**DOCUMENT 00 90 00
ADDENDUM**

ADDENDUM NO. [4] **Date: April 2, 2018**

**RE: WESTERN TECHNICAL COLLEGE
 ARC LIBRARY REMODELING & VETERAN'S CENTER ADDITION
 400 SEVENTH STREET NORTH
 LA CROSSE, WISCONSIN 54601
 HSR PROJECT NO. 17026**

A100R1

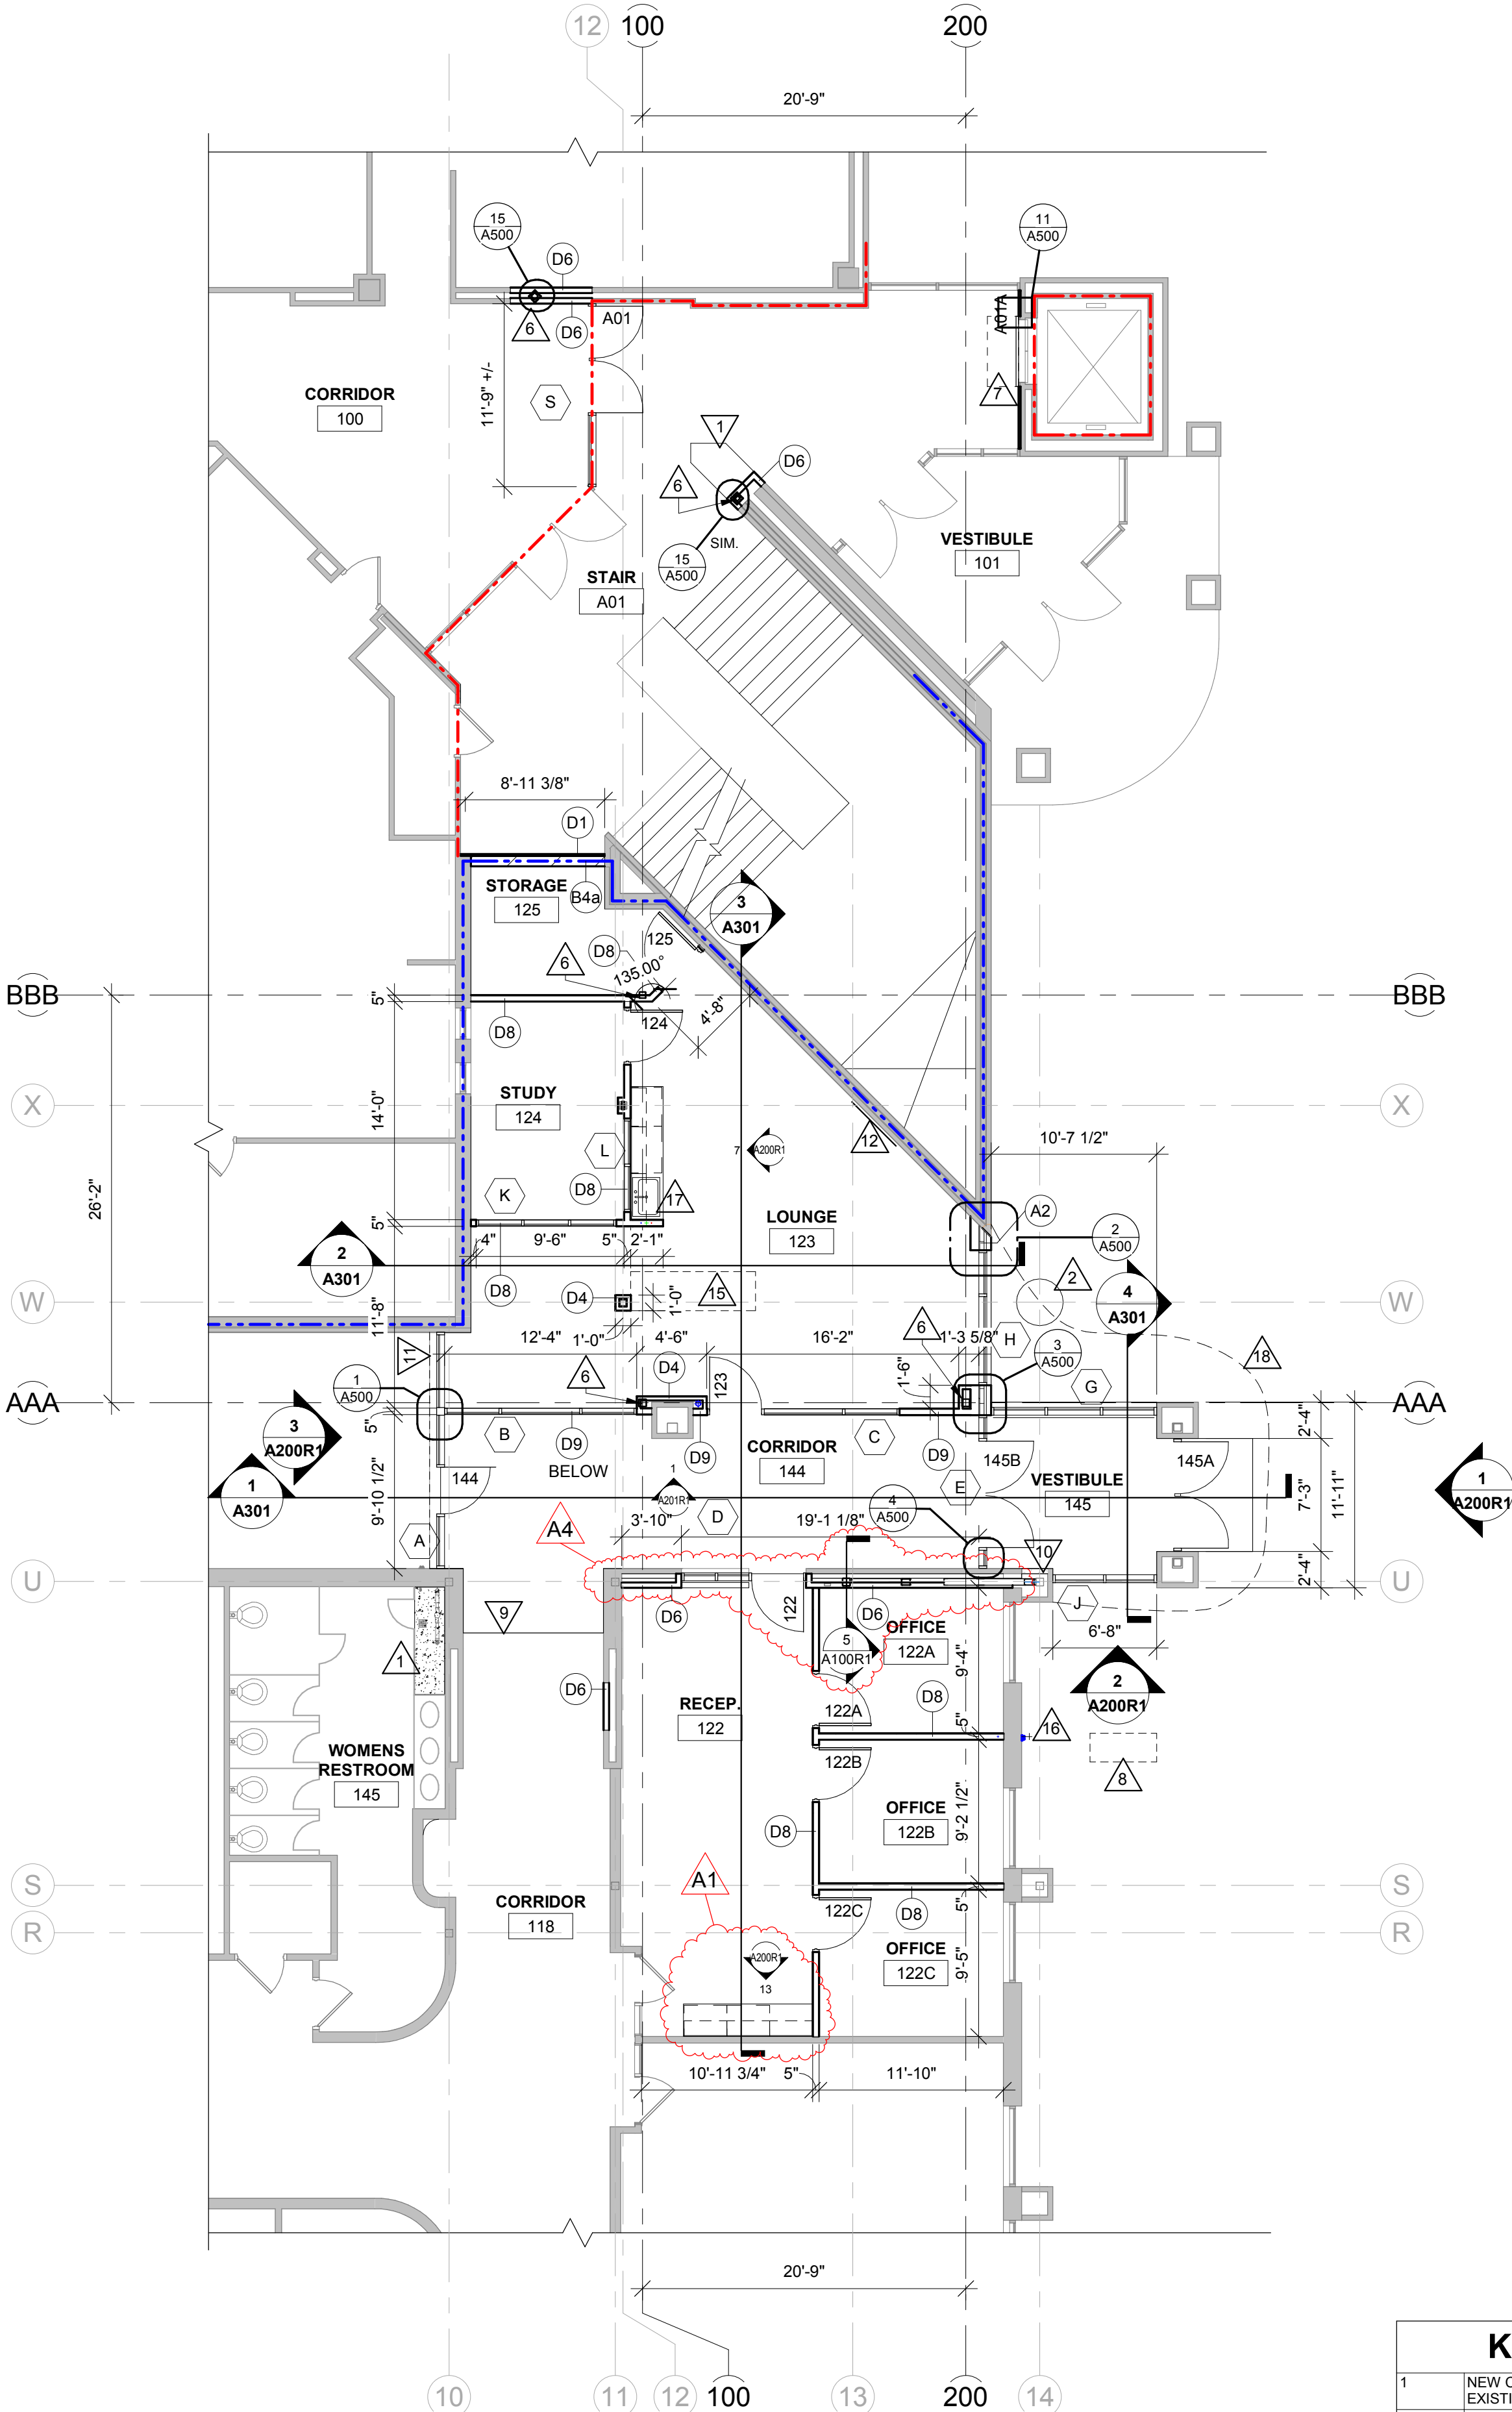
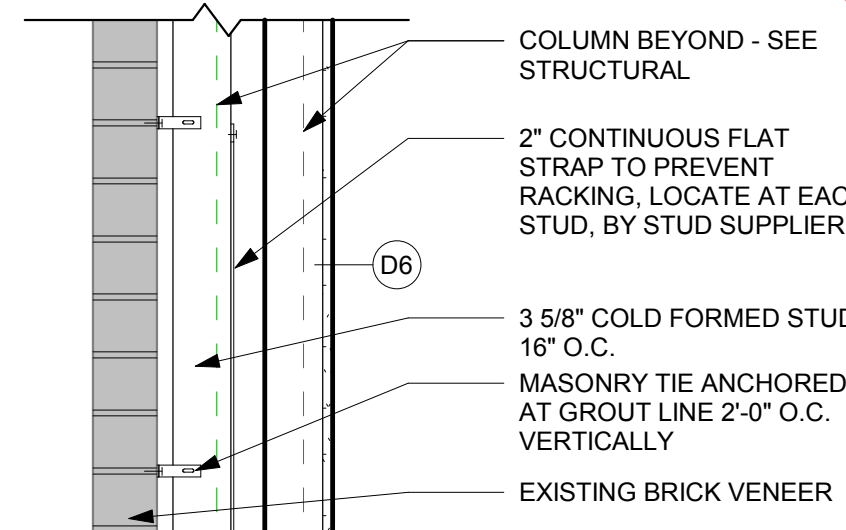
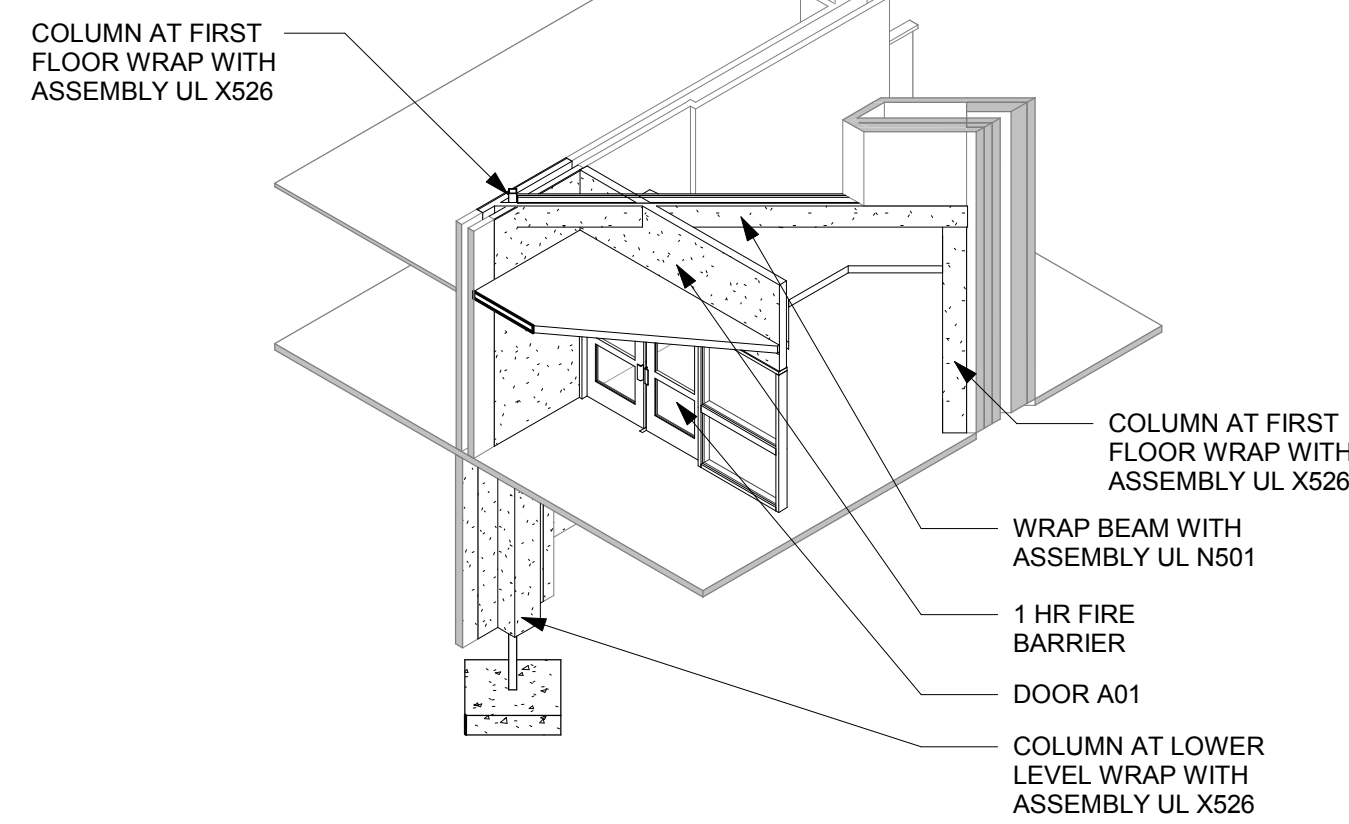
1. Sheet A100R1 30 x 42 attached hereto
 - a. Revisions clouded on Drawing.
2. Sheet A101R 30 x 42 attached hereto
 - a. Revisions clouded on Drawing.
3. Sheet A201R1 30 x 42 attached hereto
 - a. Revisions clouded on Drawing.
4. Sheet ID101R
 - a. Revised number of existing windows, Delete WS-1 along west wall of rooms 201 and 202 per sheet A101R.
